**ASHLAND PLANNING DEPARTMENT
PRE-APPLICATION CONFERENCE
COMMENT SHEET**
February 15, 2023

SITE: 381 South Mountain Avenue
APPLICANT: Rogue for Yuma
REQUEST: Site Design Review, Exception, Variance

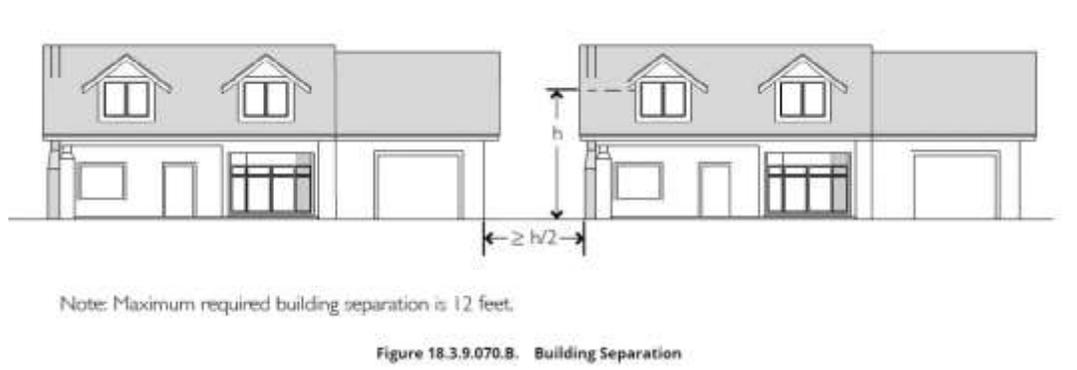
In staff's view, the key issues will be in justifying Variances/Exceptions to the required clear width for the driveway access and required landscaped screening at the property line given the proximity of the existing house to the north property line. In both instances, staff believe there is a case to be made which supports these requests given the location of the existing house, the narrow lot width, and the desire to achieve more efficient land use. Staff are generally supportive and look forward to seeing this project move forward. As the applicant works to prepare final submittal materials, key items which should be considered include:

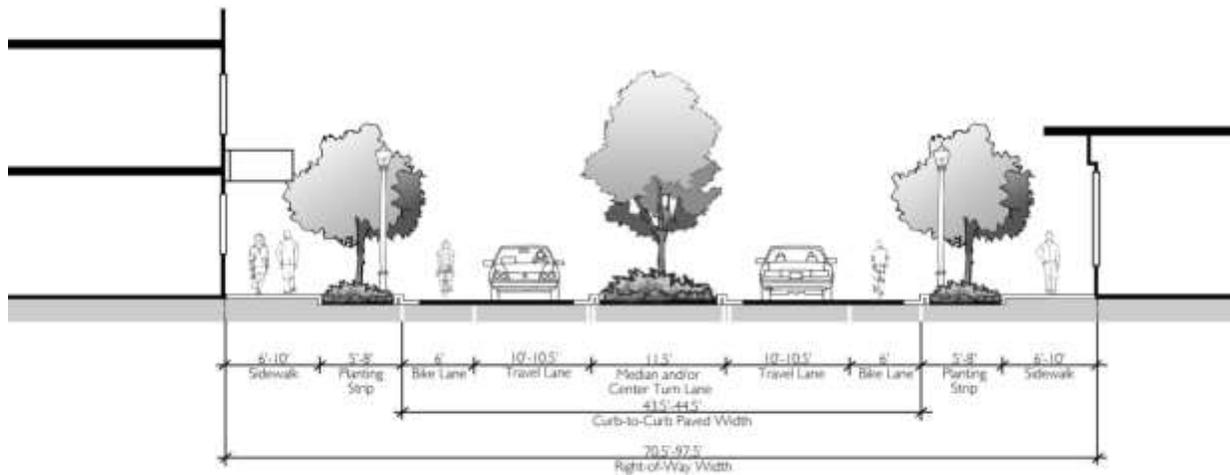
- **Solar Access:** For “Standard B” lots (based on width & average slope), solar access standards limit the shadow that can be cast over the north property line to no more than what would be cast by a 16-foot tall fence built on the property line. The final application will need to include demonstration of compliance with the solar access standards as detailed in AMC 18.4.8 (i.e. calculations in the form of [(Shadow Producing Height(H) – 16)/(0.445 + Average Slope (S) 150-feet to the north) = Required Solar Setback (SSB)] with the shadow-producing point(s) and their height(s) to natural grade clearly labeled.
